### **ADDENDUM #1** **TEHAMA COUNTY BUS SHELTER INSTALLATION PROJECT** **PLANS AND SPECIAL PROVISIONS** **COUNTY PROJECT NUMBER: 973037**

### ADDENDUM #2

#### TEHAMA COUNTY BUS SHELTER INSTALLATION PROJECT PLANS AND SPECIAL PROVISIONS COUNTY PROJECT NUMBER: 973037

ADDENDA EXHIBIT 2-A

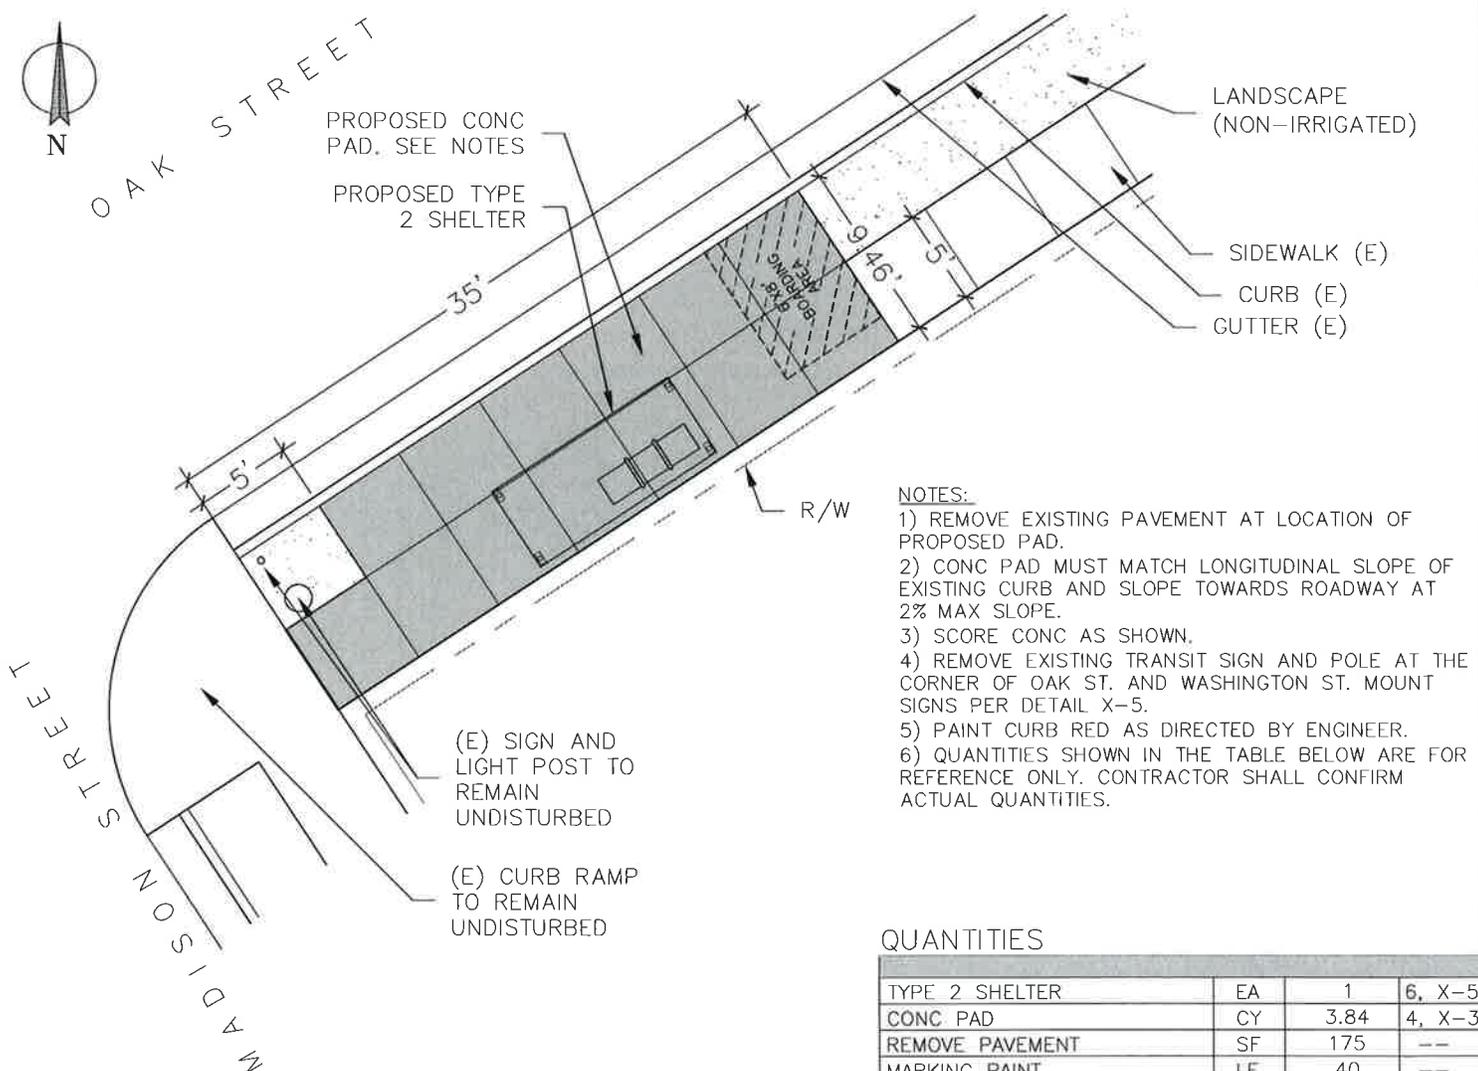
Refer to the project plans. Site 4 at Red Bluff City Hall has been relocated approximately 330' westerly to the corner of Oak St. and Madison St. Some estimated quantities have changed.

Replace plan sheet P-4, page 14 of 37 with attached "Exhibit 2-A"

**ADDENDA EXHIBIT 2-B**

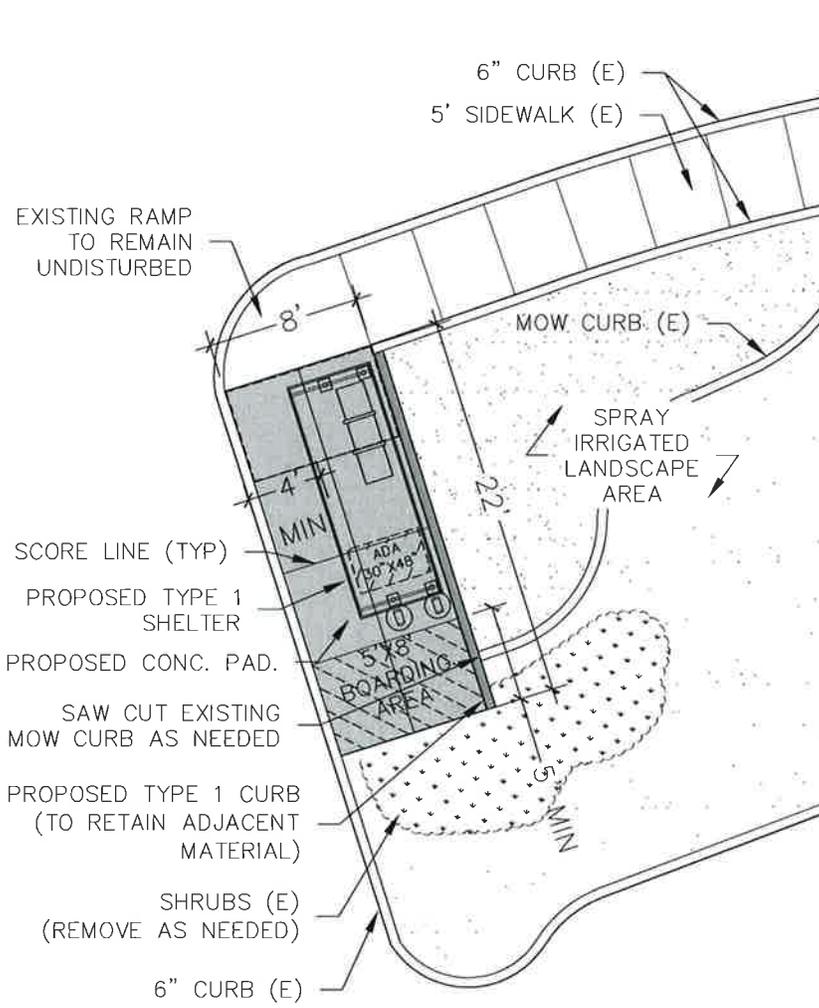
Refer to the project plans. The concrete pad at Site 8, Chevron Gas Station, has been lengthened from 20 feet to 22 feet. Some estimated quantities have changed.

Replace plan sheet P-8, page 18 of 37 with attached "Exhibit 2-B"

ADDENDA EXHIBIT 2-C

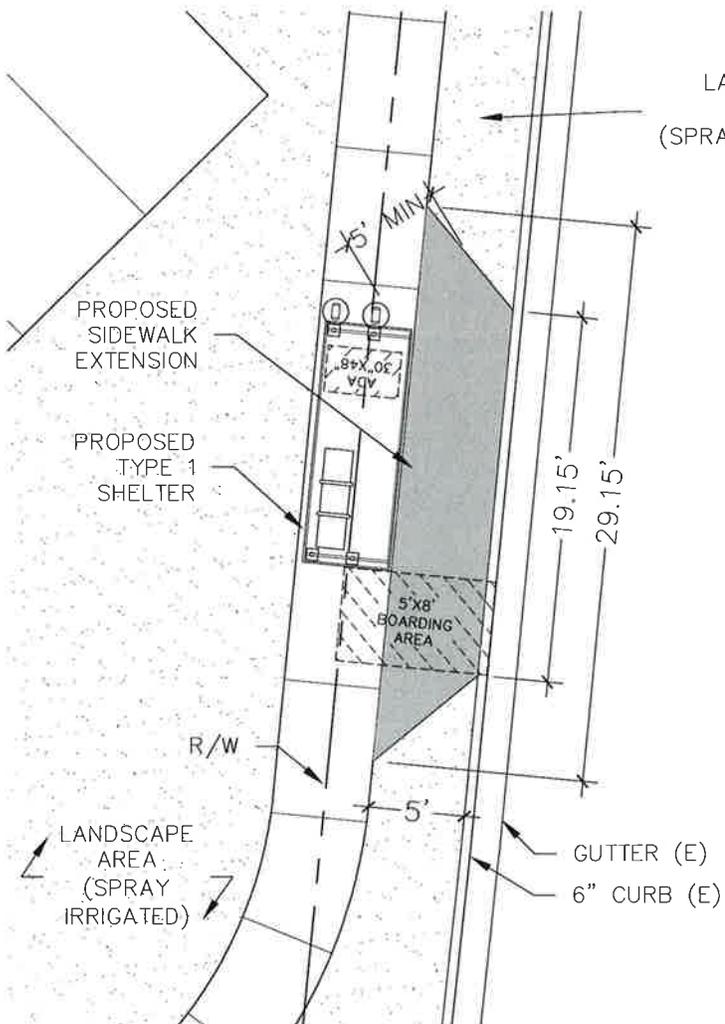
Refer to the project plans. Site 9 at Greenville Rancheria has been relocated approximately 30' northerly on Montgomery Rd. Some estimated quantities have changed.

Replace plan sheet P-9, page 19 of 37 with attached "Exhibit 2-C"

**ADDENDA EXHIBIT 2-D**

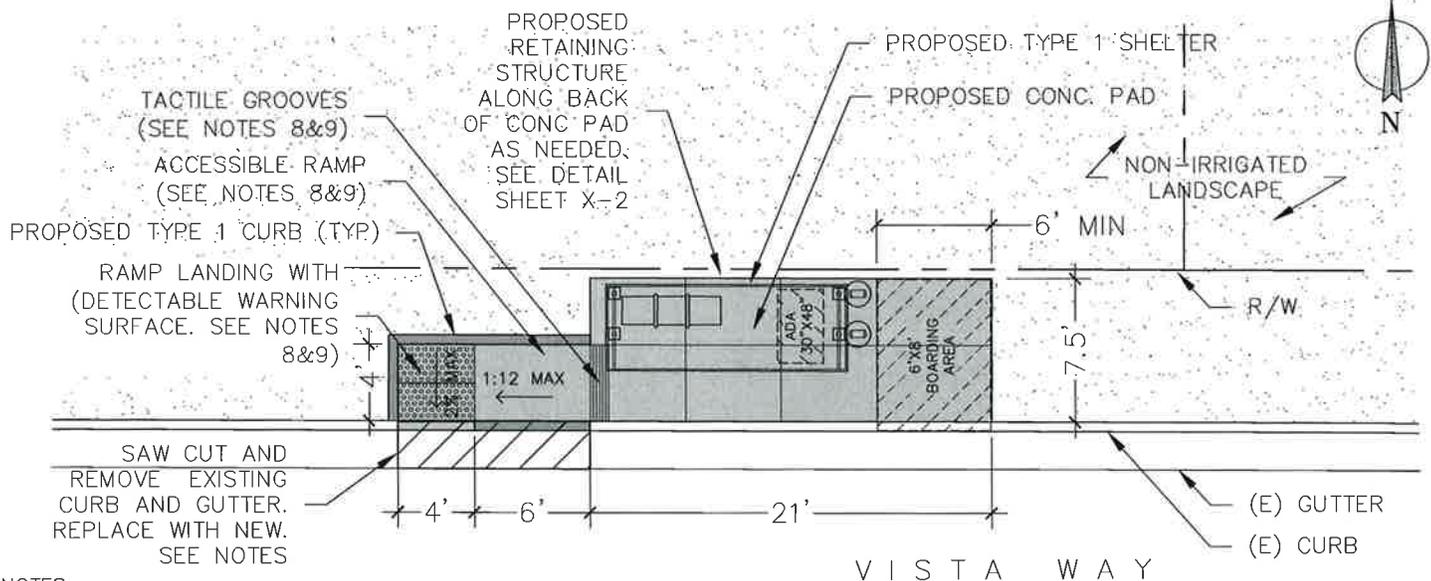
Refer to the project plans. Site 10 at Vista Way and Hornbeck St. has been relocated approximately 290' westerly to the corner of Vista Way and Bidwell St. Some estimated quantities have changed.

Replace plan sheet P-10, page 20 of 37 with attached "Exhibit 2-D"

ADDENDA EXHIBIT 2-E

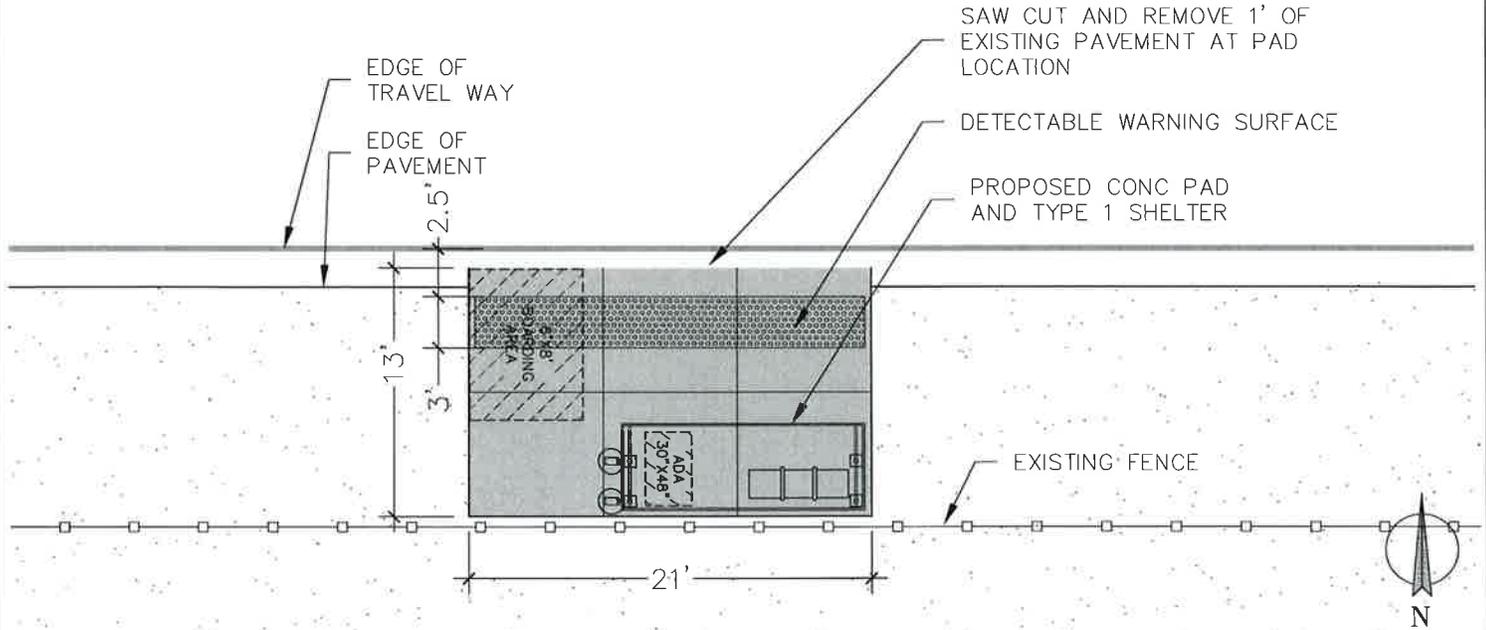
Refer to the project plans. Site 23 at 99W and Proberta has been relocated approximately 250' northwesterly on Flores Ave. Some estimated quantities have changed.

Replace plan sheet P-23, page 33 of 37 with attached "Exhibit 2-E"

**ADDENDA EXHIBIT 2-F**

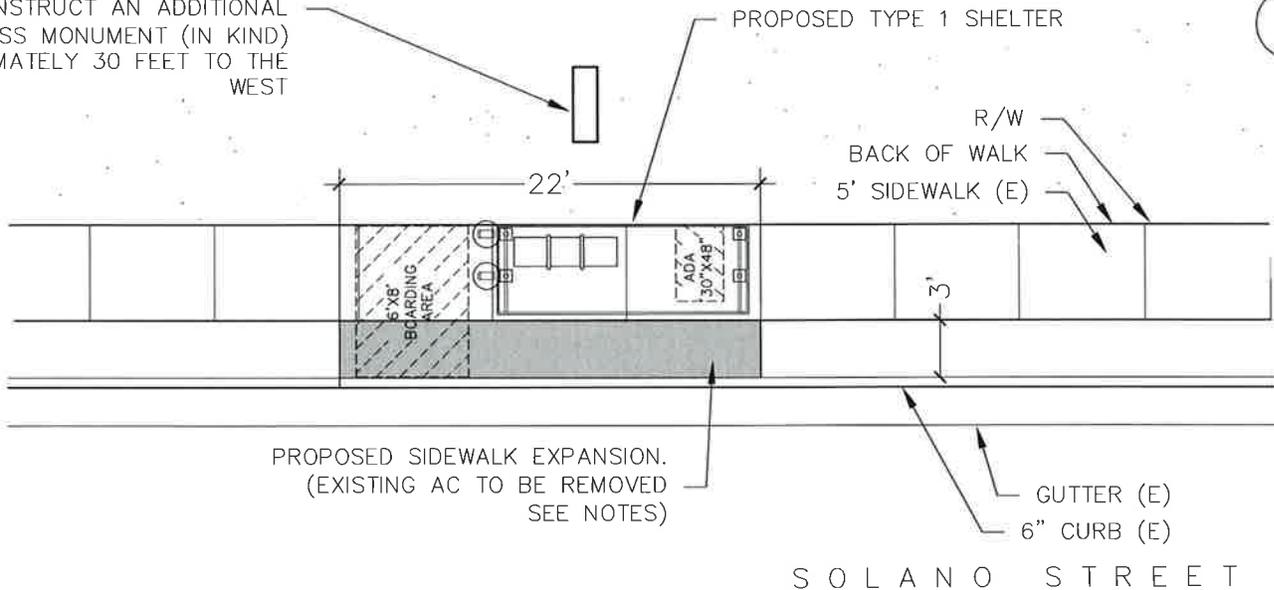
Refer to the project plans. Site 26 at Dollar Tree has been relocated approximately 110' easterly. Some estimated quantities have changed.

Replace plan sheet P-26, page 36 of 37 with attached "Exhibit 2-F"

**ADDENDA EXHIBIT 2-G**

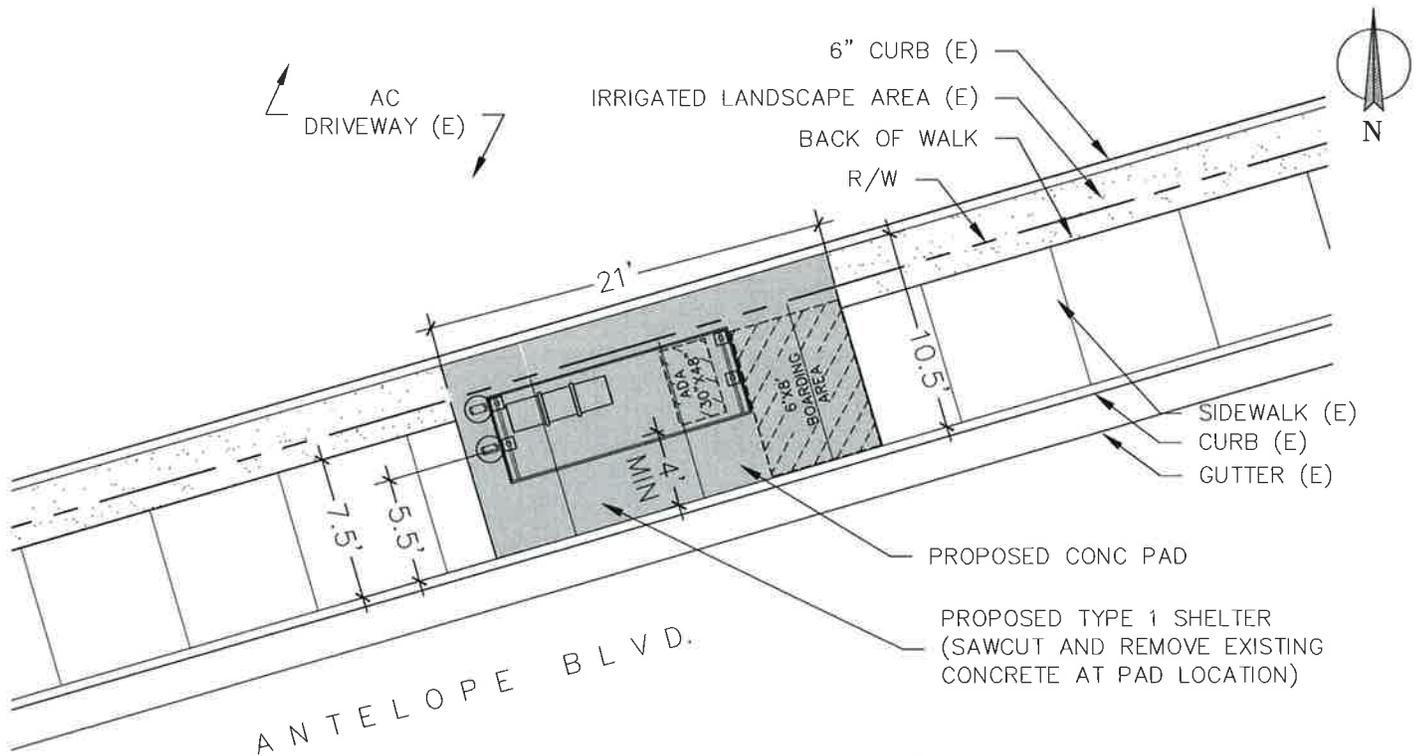
Refer to the project plans. The concrete pad at site 27, Shell Gas Station, has been widened from 8 feet wide to 10.5 feet wide. Some estimated quantities have changed.

Replace plan sheet P-27, page 37 of 37 with attached "Exhibit 2-G"

ADDENDA EXHIBIT 2-H

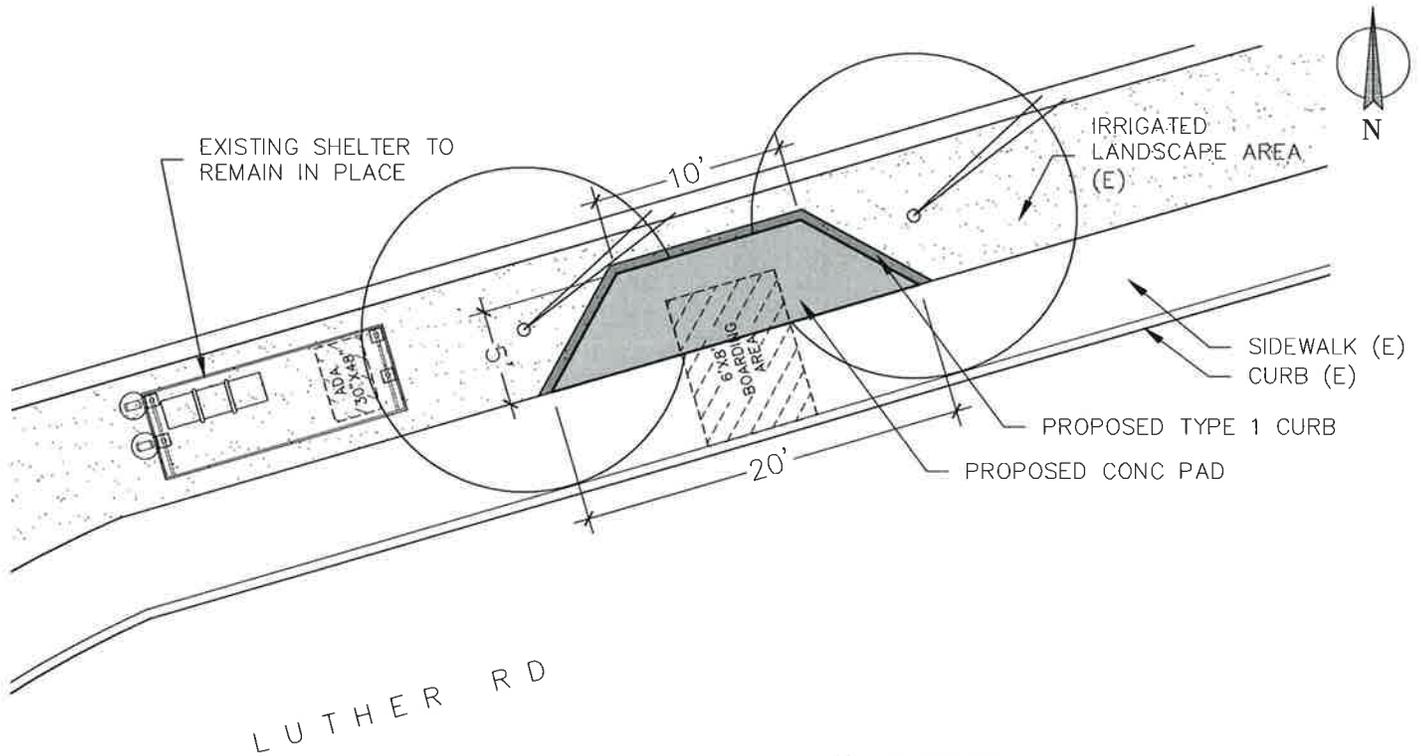
Refer to the project plans. An additional site has been added. Concrete pad and Type 1 curb improvements shall be added to the existing bus stop location located approximately 160 feet south of Luther Rd. in Red Bluff.

Project plans shall now include page P-28 "Exhibit 2-H"
